Title: XH-M139 (ver.3) TPA3116D2 2.1 Channel digital Amplifier

Sheet: /	
File: TPA3116D2_3D-AMP.sch	
Title: Modified XH-M139 v3 TPA3116D2 2.1 Channel digital Amplifier	
Size: A4	Date: 2018-11-18
KiCad E.D.A. kicad (5.0.1-3-g963ef8bb5)	Rev: 1/1

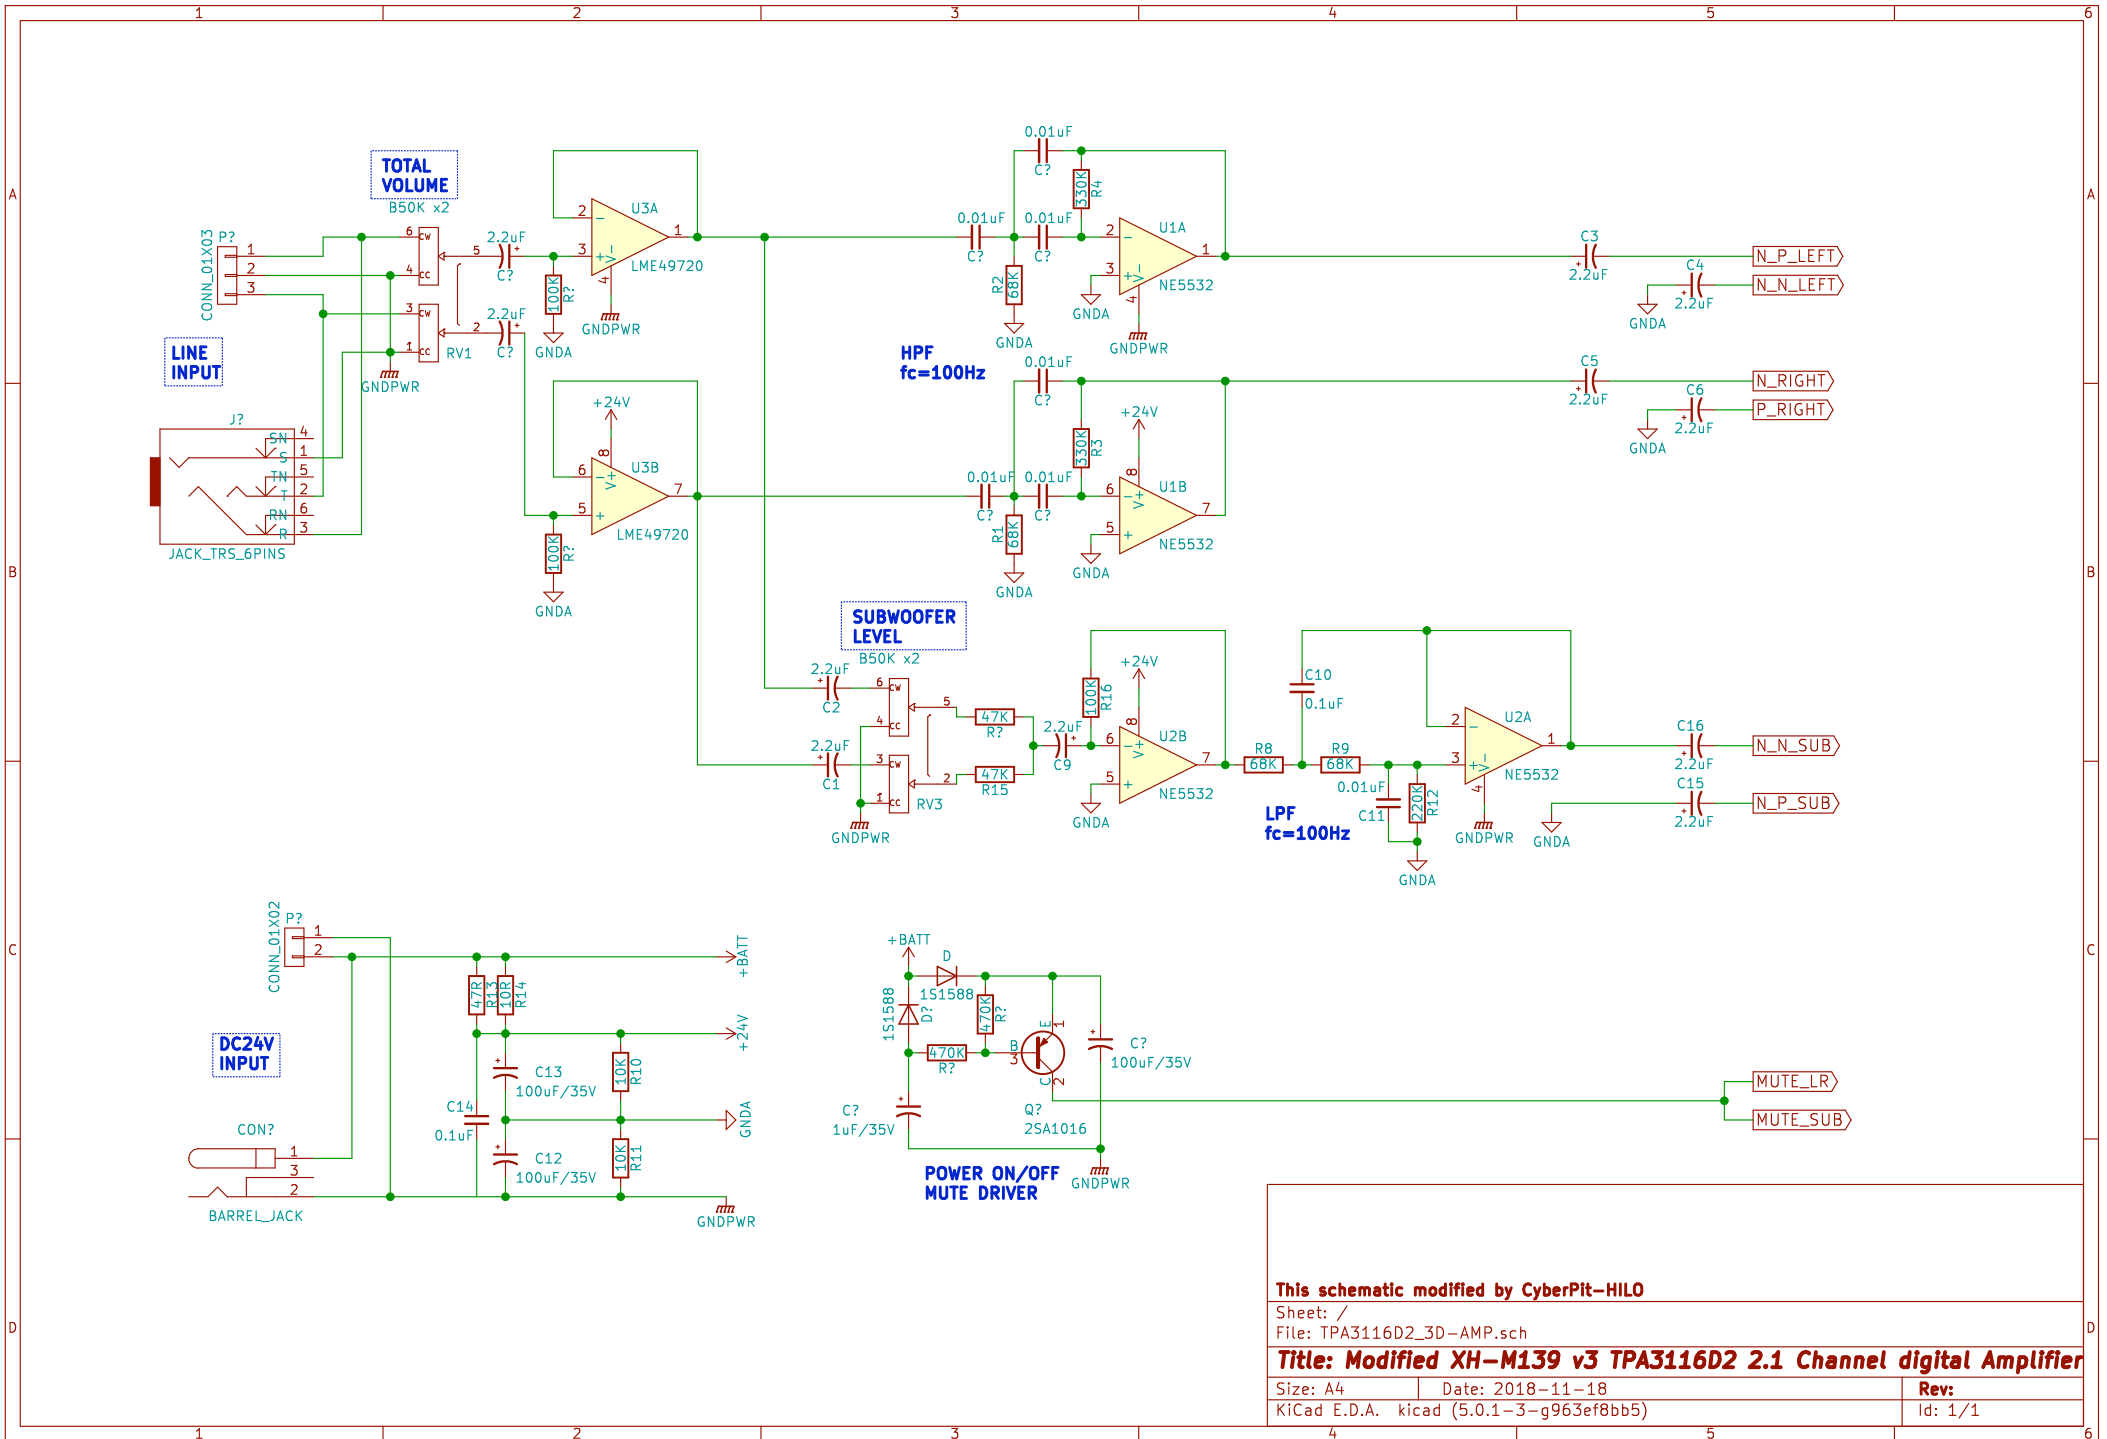
SUGGESTION:
 This output signal line should drive with low impedance signal source.
 If the source impedance is high, then you'll hear much TPA3116D2 noises.

ISSUE:
 Bad mixing circuit design.
 U1 output will be short when RV2 is set at CW position.
 Not enough low source impedance for LFP section.

SUGGESTION:
 R12 is too low impedance. Affects cut-off frequency.
 Better to move between C9 and R8
 or raise impedance.

SUGGESTION:
 GNDPWR will not be stable when +BATT shaking.
 Better to change connection to GNDPWR

SUGGESTION:
 GNDPWR will not be stable when +BATT shaking.
 Better to change connection to +24V

ISSUE:
 NO Muting function provided!
 Too much POPs

Power-Stage (After Modification)

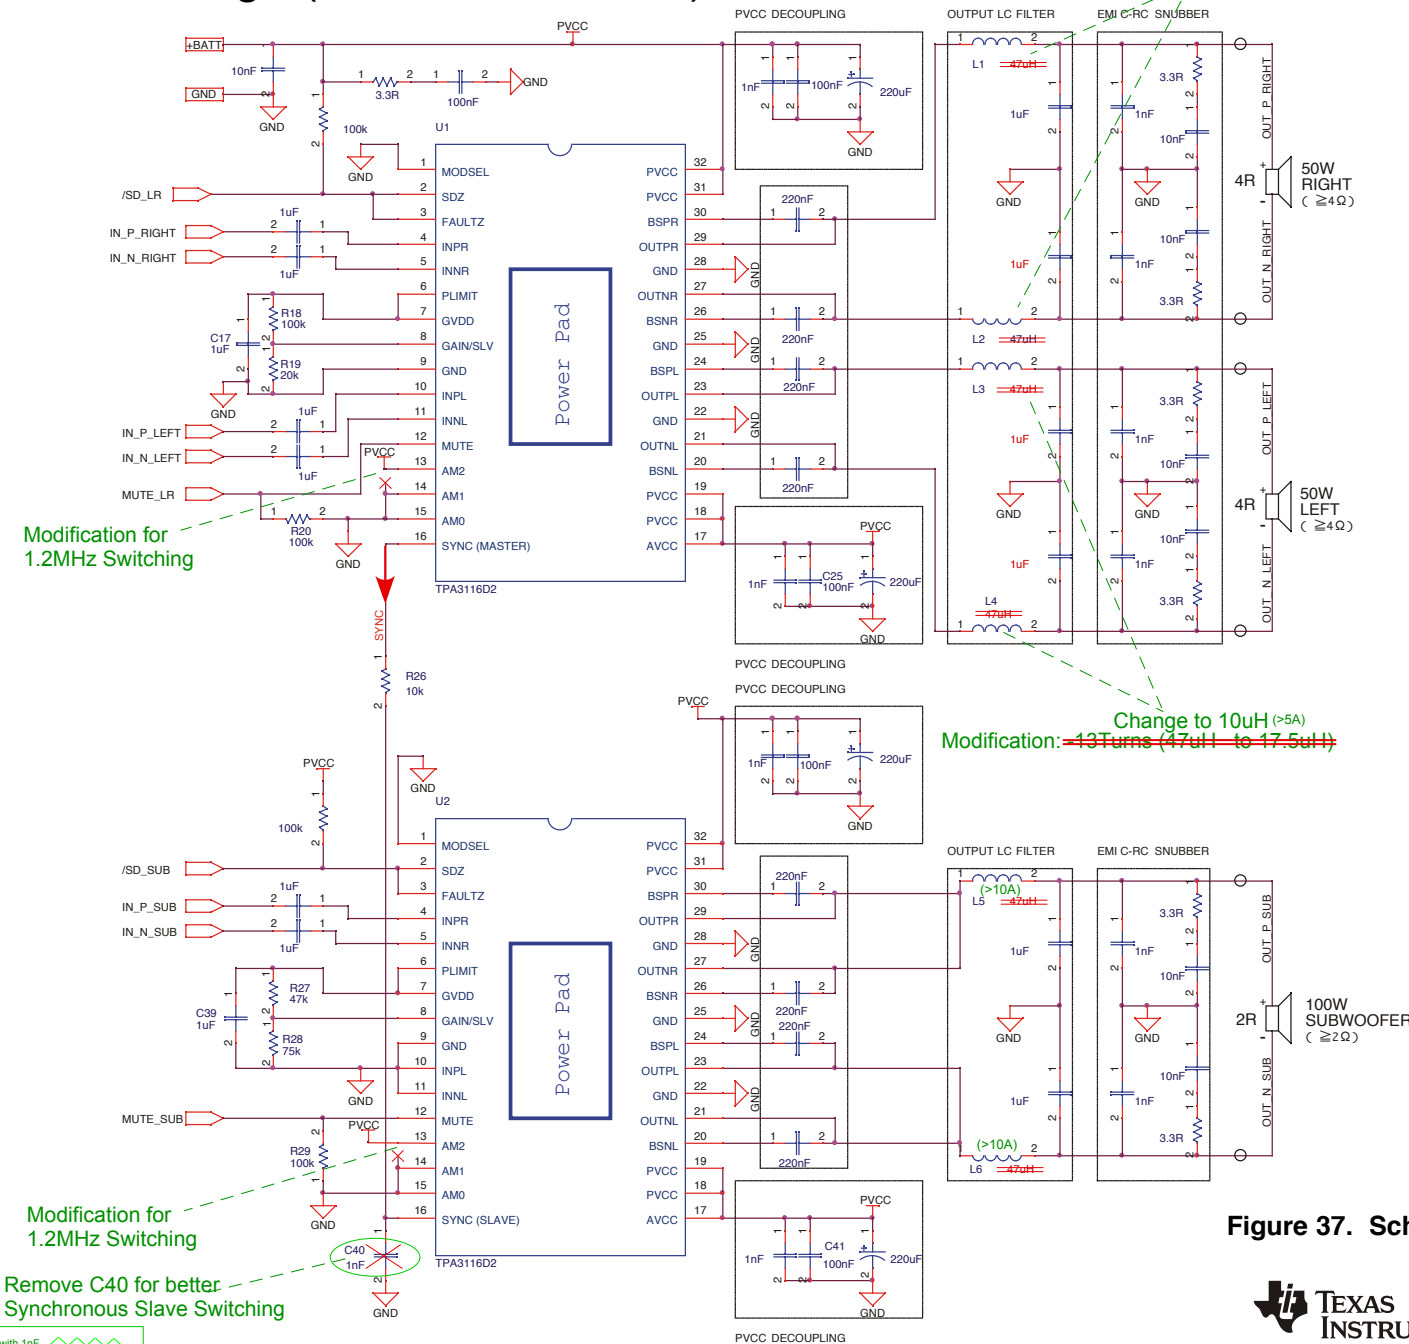
- (Power-Stage)
- ・スイッチング周波数を400kHzから1.2MHzに
 - ・ON/OFF時のミュートング駆動回路を追加
 - ・スレーブ同期用のクロック信号入力のCを削除
 - ・出力LPFのインダクター巻数変更したが結局
→磁気飽和しにくい大電流対応の10uH品に交換
